# Conceptual Review Agenda

# Maple Hill Park

**Re:** Maple Hill Park

**Description of project:** This is a request to build a City park in the Maple Hill neighborhood (Parcel #8832242909). The park is identified as a Neighborhood Park in the Parks and Recreation Policy Plan. The proposed park will feature a multi-purpose field, playground and trail connections. The parcel is located in the Low Density Mixed-Use Neighborhood (LMN) zone district. The proposal will be subject to Basic Development Review (BDR).

concept C

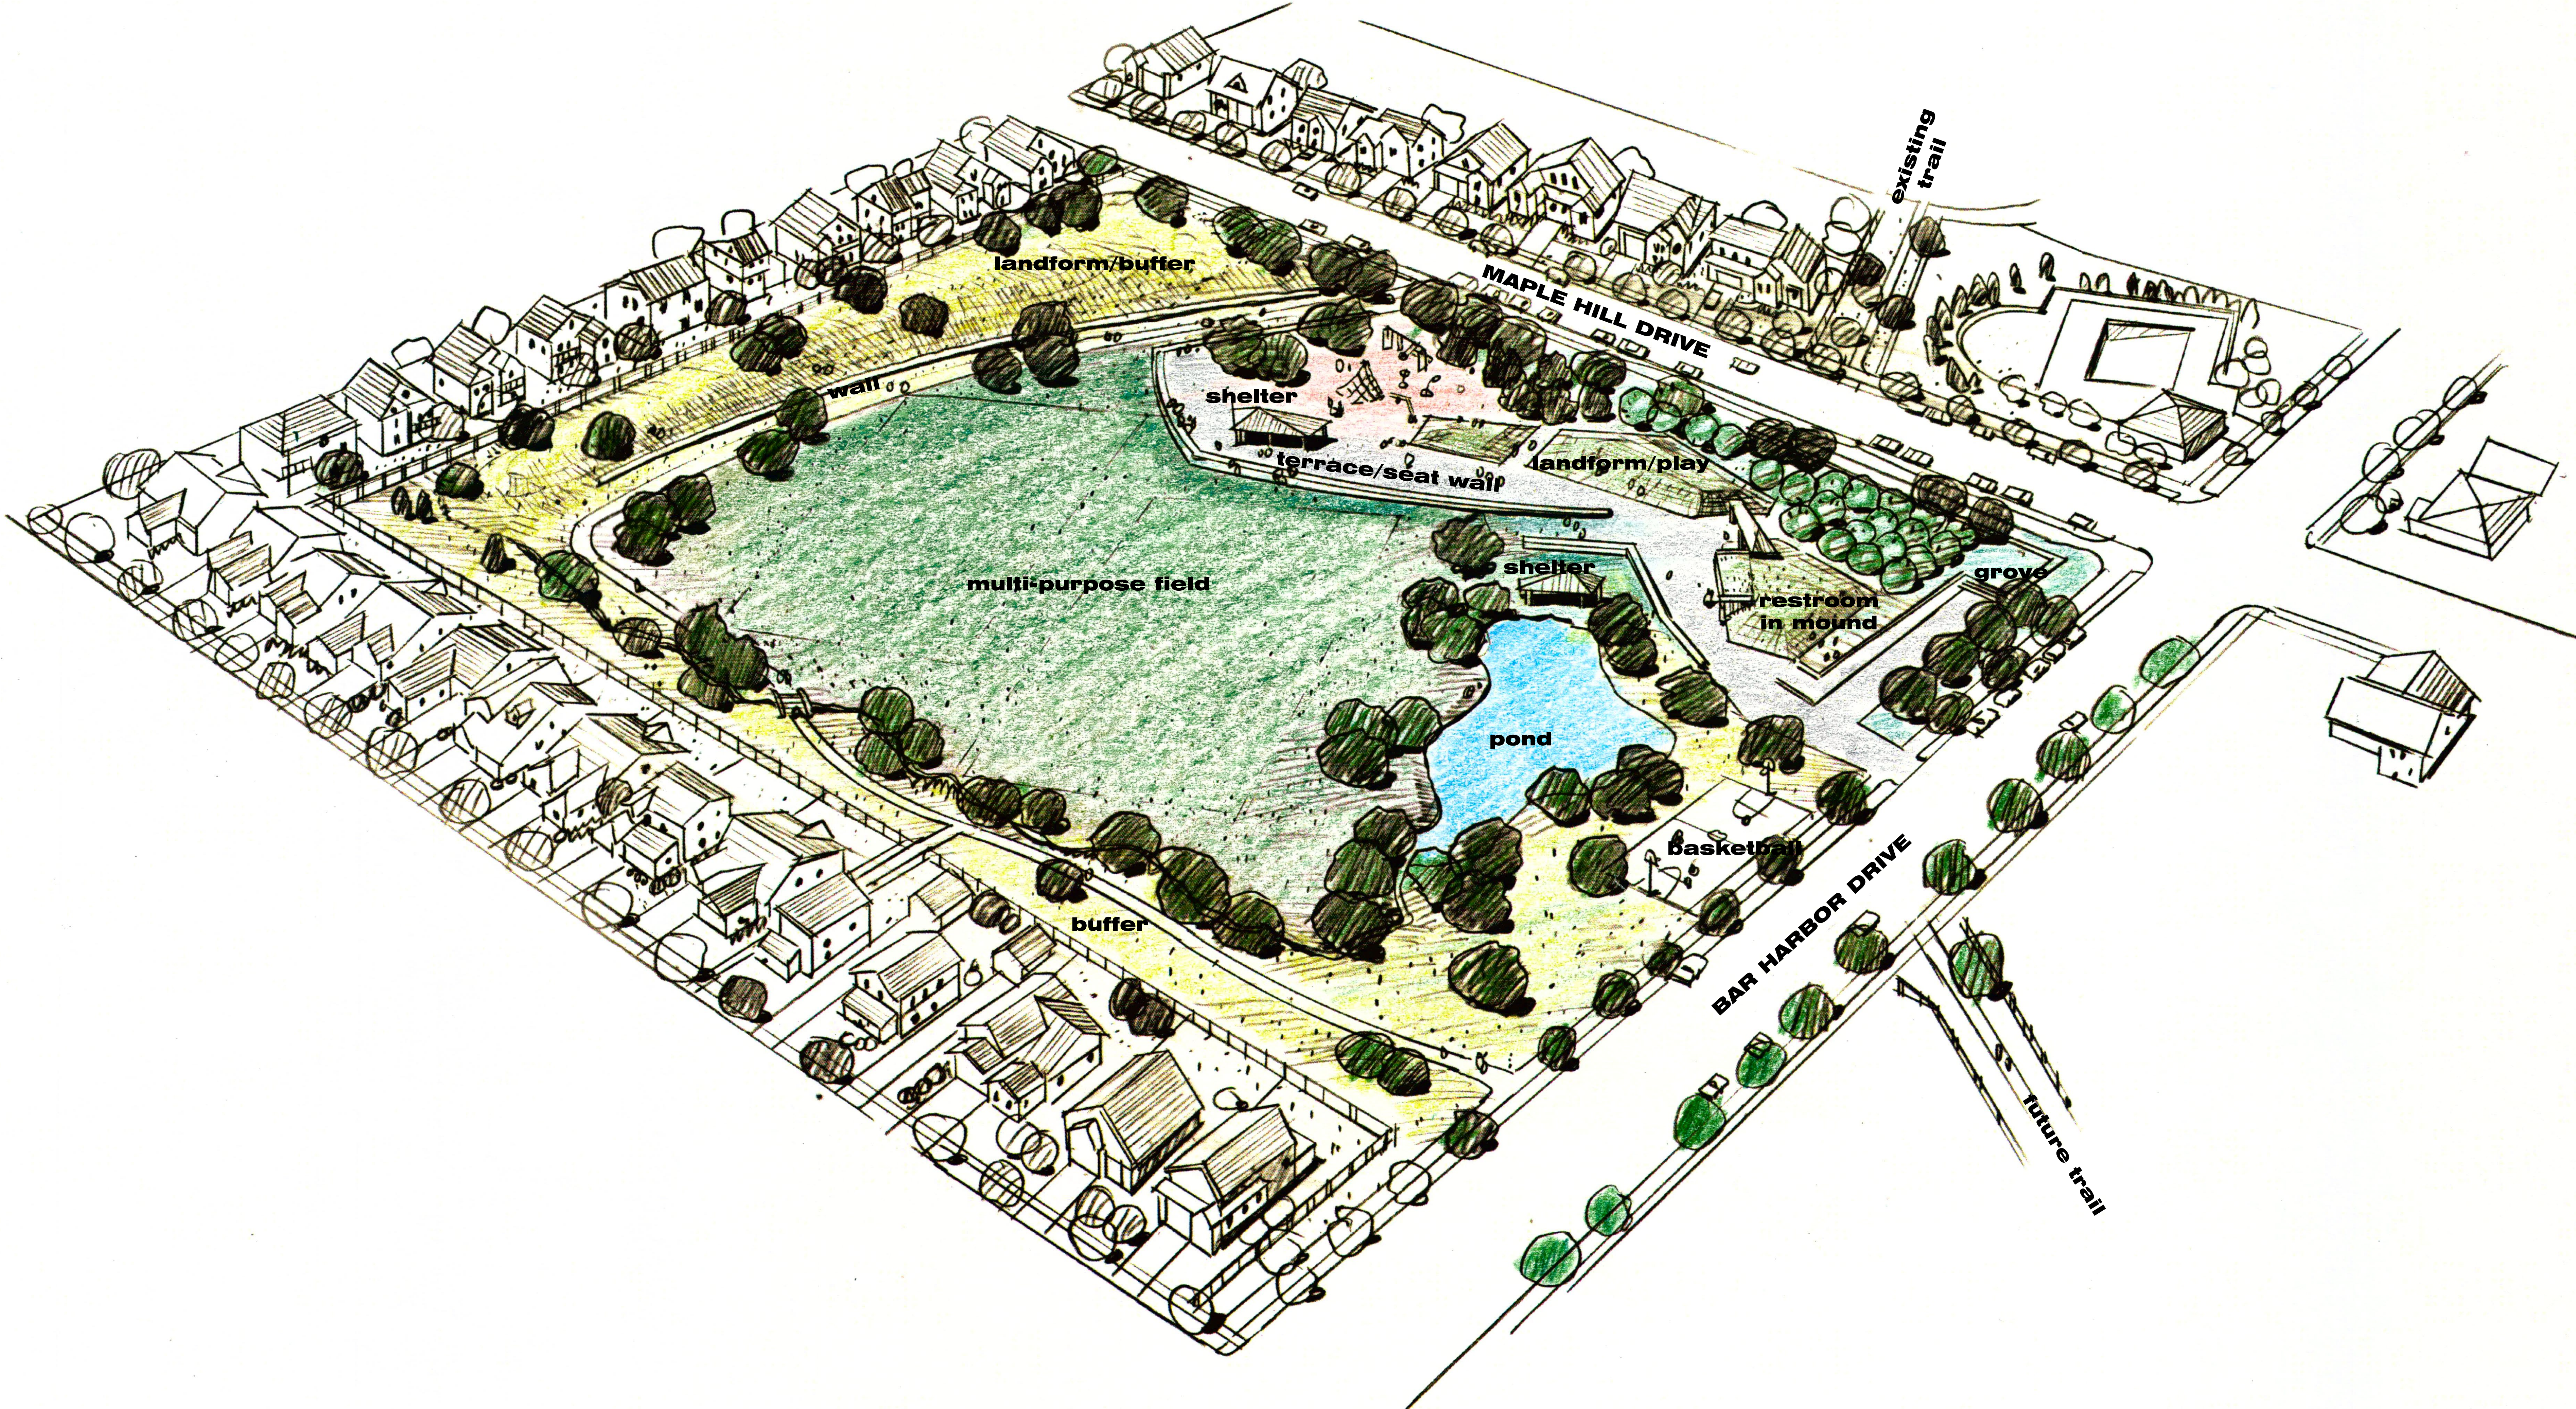
1. It is assumed that the neighborhood park was included in the original planning for the neighborhood. In addition, any additional vehicular traffic due to the park is not expected to rise to the threshold of needing a TIS. Based on section 4.2.3.D of LCUASS, the Traffic Impact Study requirement can be waived.
2. Any adjacent streets not yet completed need to be completed. This includes sidewalks along Maple Hill.
3. Please plan to include ample bike parking.
4. Is there a curb cut and parking lot along Bar Harbor? It's difficult to tell from the sketch.

1. Can the park design be adjusted to provide more direct trail street crossings and trail flow through the park.
2. The proposed development is subject to a Basic Development Review, please contact the Zoning Department regarding your formal submittal.

1  
A2.1 BUILDING PERSPECTIVE

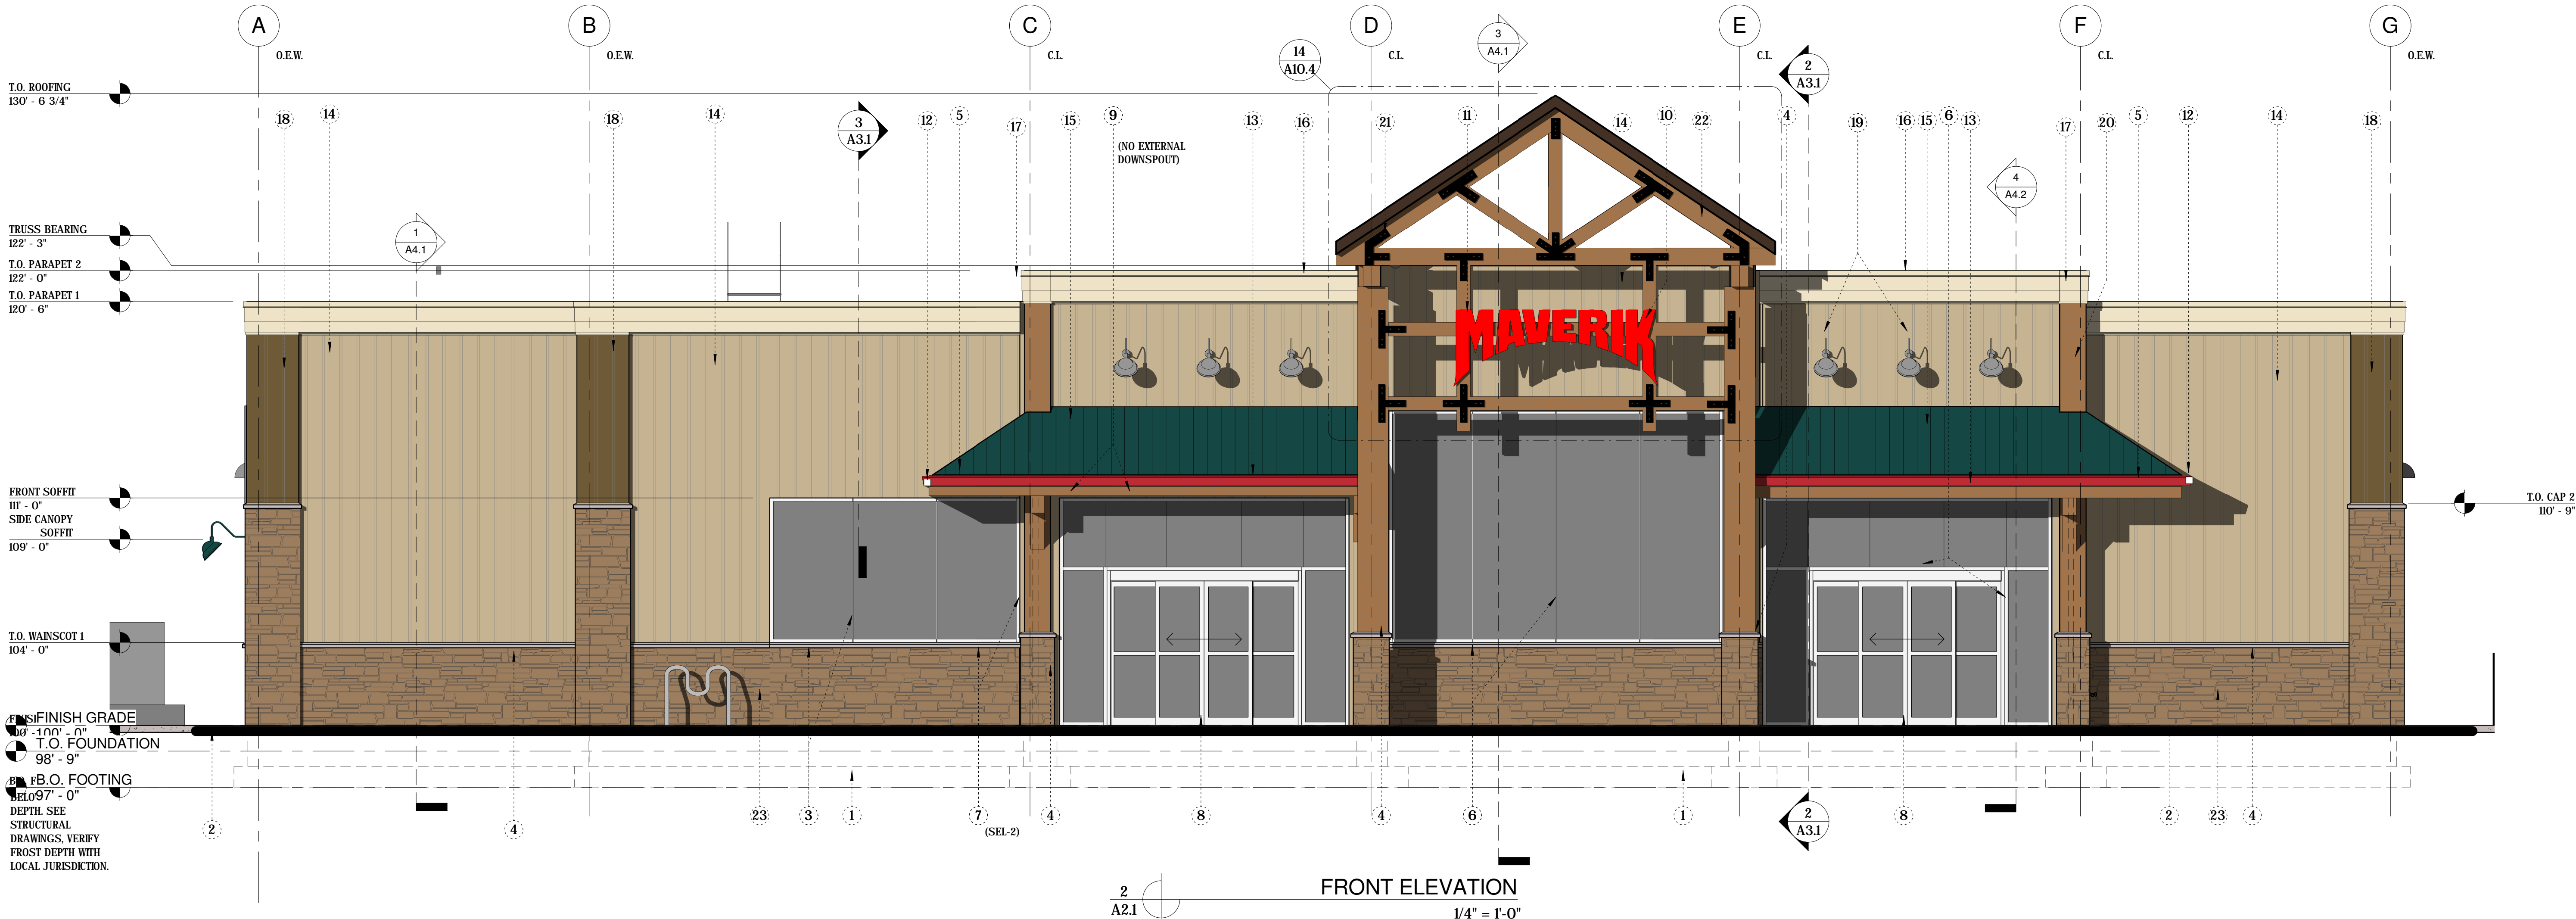
19. In order to determine the depth and perspective of the cornice, please provide a cornice detail with dimensions.
20. Regarding the fuel canopy, staff is concerned about its overall mass due to the length. At 108 feet long, the canopy needs multiple roof lines. A simple flat roof appears monotonous and needs relief. The architect needs to consider introducing gable ends, sloping parapets, pitched roofs or any other combination or design that breaks up the repetitiveness of the length. The "dog house" feature appears to be limited in scope and location is acceptable.

REAR ELEVATION  
1/4" = 1'-0"

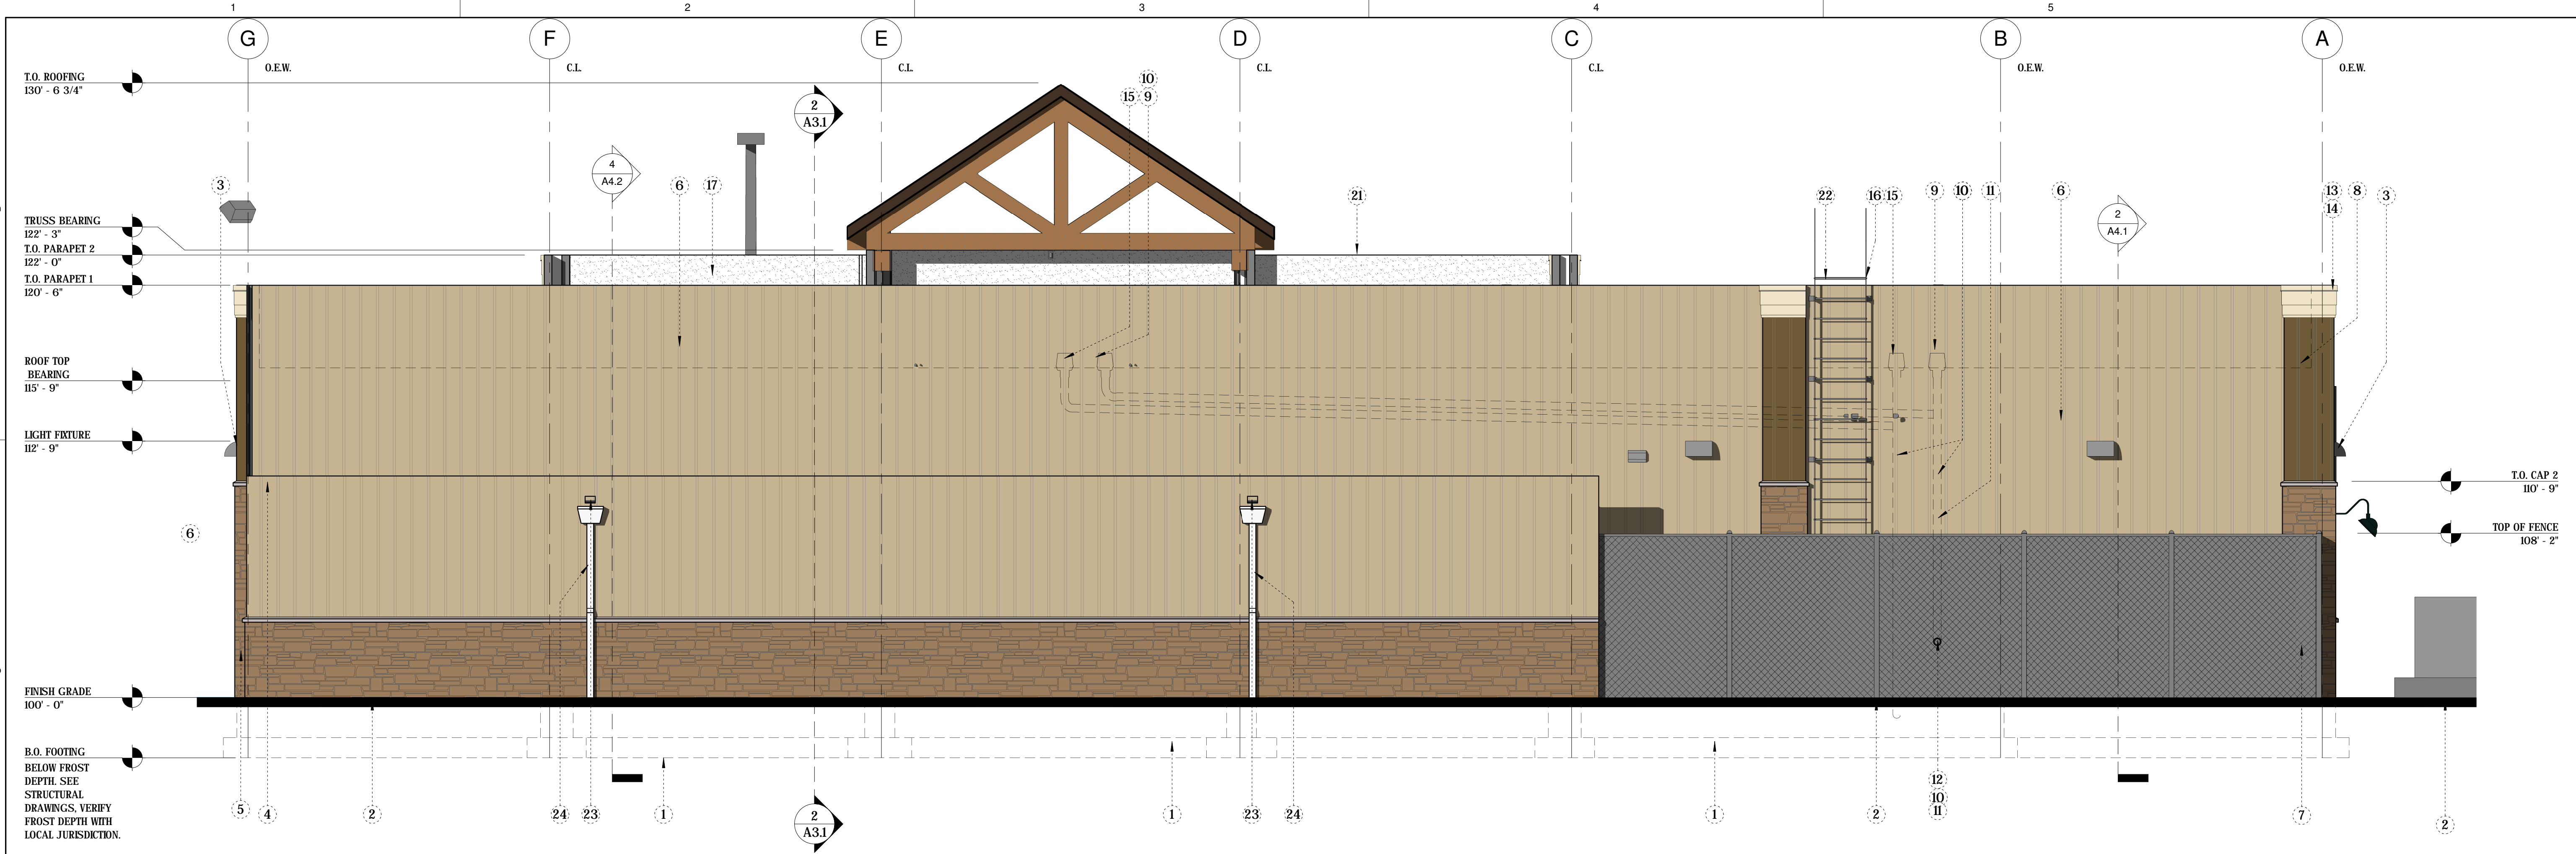
17. The right side includes the door with detail features, including the gooseneck light fixtures. Please provide a perspective of this elevation so the extent of the projections of the columns and door treatment can be determined.

18. The left side lacks the detail of the right side. This elevation would comply by introducing a canopy and gooseneck light fixtures that continue the established pattern.
